MONITORING YEAR 3 ANNUAL REPORT Final

FOUST CREEK MITIGATION SITE

RE: Task 8 – Draft Monitoring Year 3 Annual Report Comments
Foust Creek Mitigation Site (DMS #95715)
Cape Fear River Basin 03030002, Alamance County
Contract No. 004954

Figure 2 Project Component/ Asset Map
 Foust Creek Mitigation Site
 DMS Project No. 95715
 Monitoring Year 3 - 2017
 Alamance County, NC

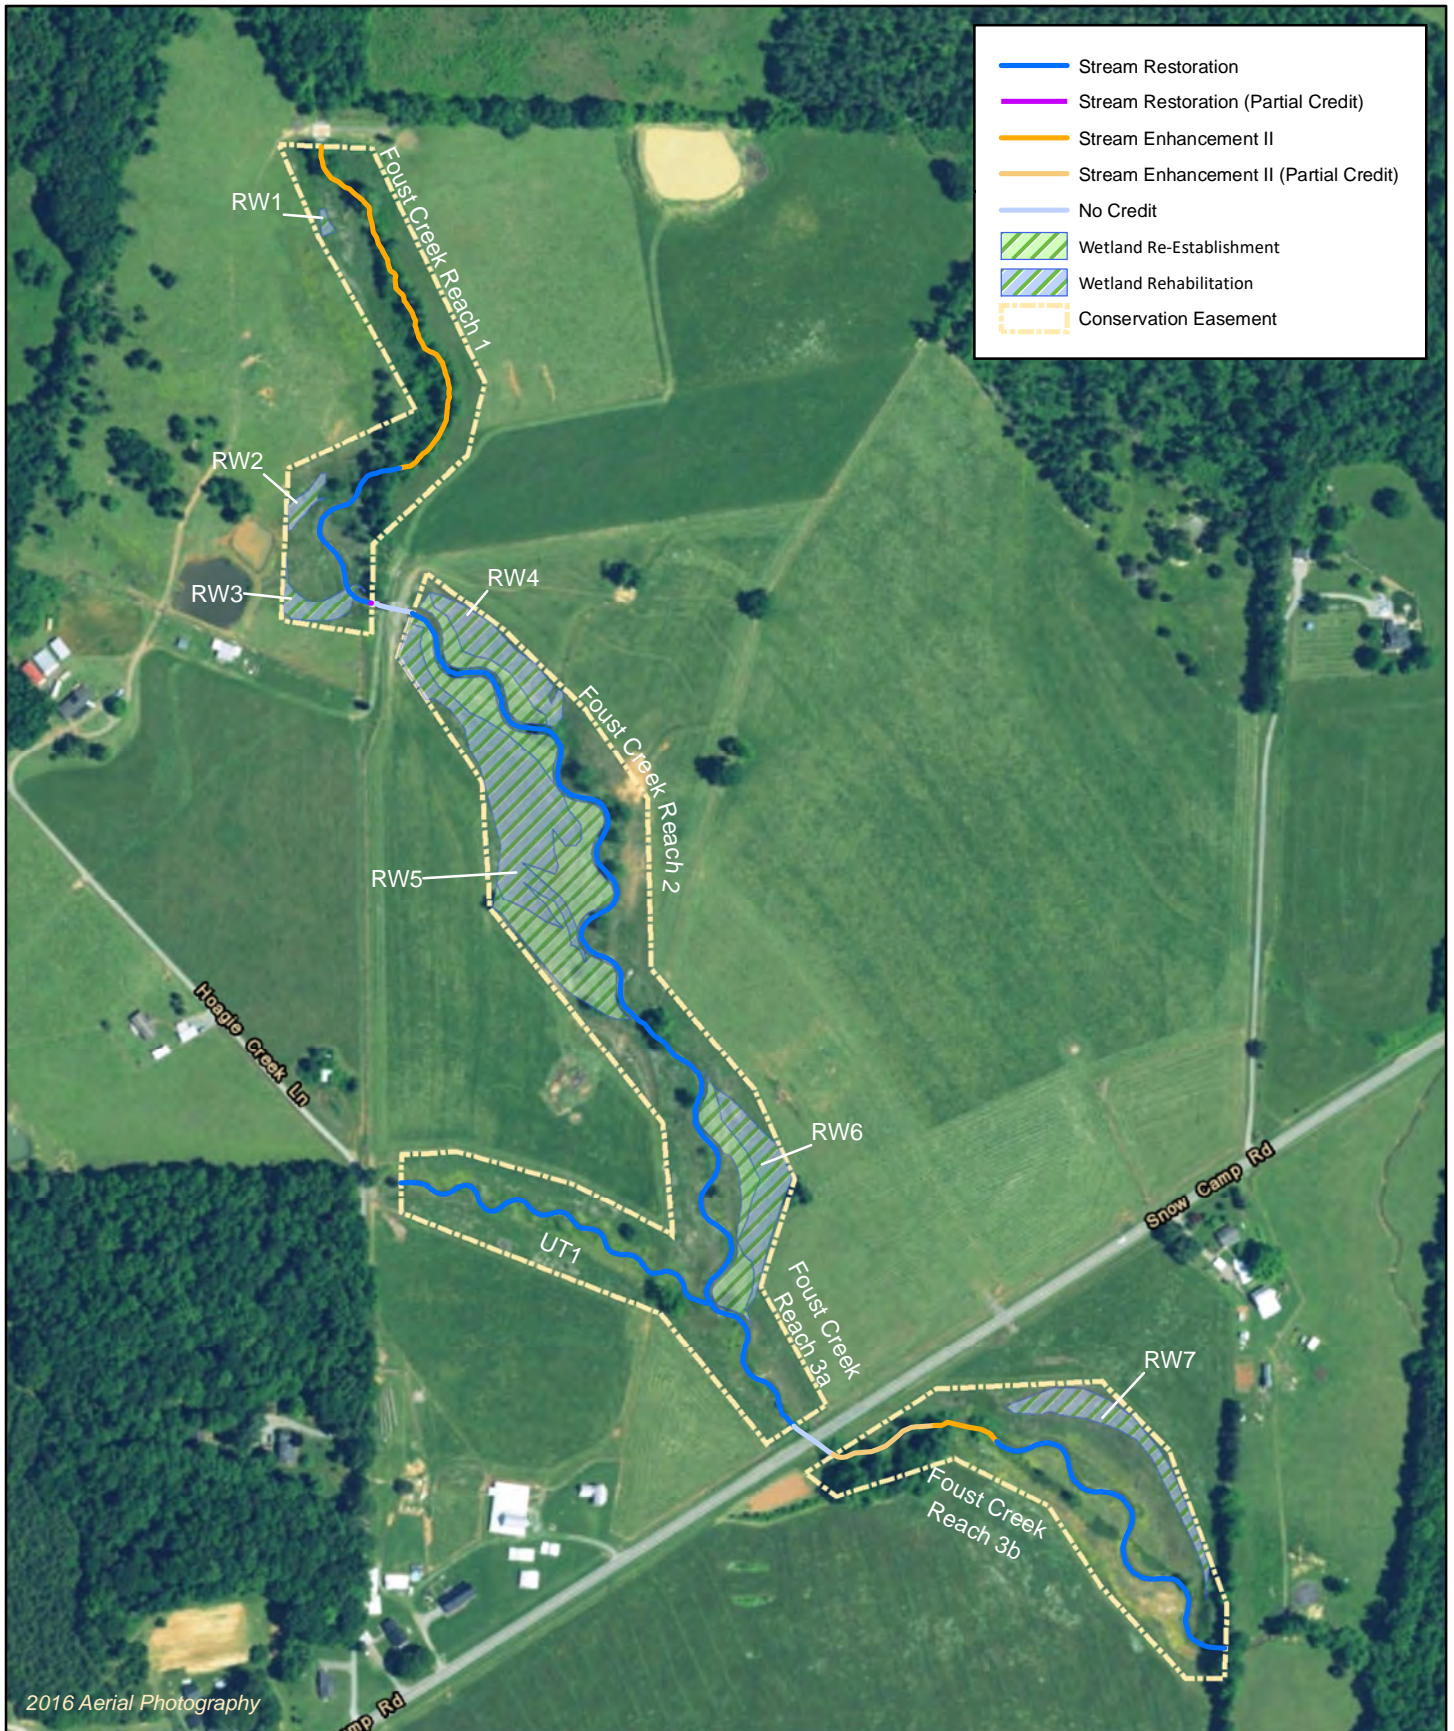
- 6) Figures 3.0, 3.1, 3.2 and 3.2: DMS unable to distinguish between Stream Restoration and Stream Restoration (Partial Credit) on the hardcopies in Appendix 2.

The color for Stream Restoration (Partial Credit) was changed to make it stand out on Figures 2, 3.0, 3.1, 3.2, and 3.3. This section of stream is only 14 feet long which makes it hard to see at a large scale.
